Hi-Fi Products Service Bulletin

Model: CDP-491

No. 298

Subject: Display Board Change

CDP-491
DISPLAY BOARD

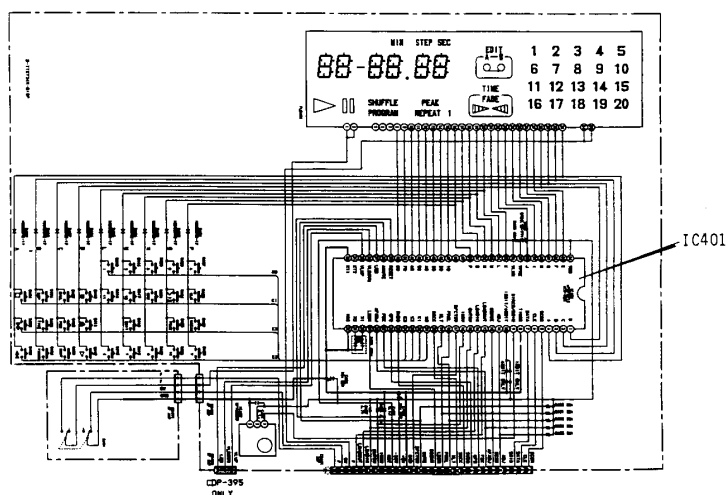
The display board layout has been changed along with IC401 which has been changed to a DIP package type component.

Refer to layout drawing below when troubleshooting and to order IC401, refer to part number shown in chart:

REFERENCE	DESCRIPTION	PART NUMBER	
		INCORRECT	CORRECT
IC401	IC uPD75212ACW-A23	8-752-817-41	8-759-058-72
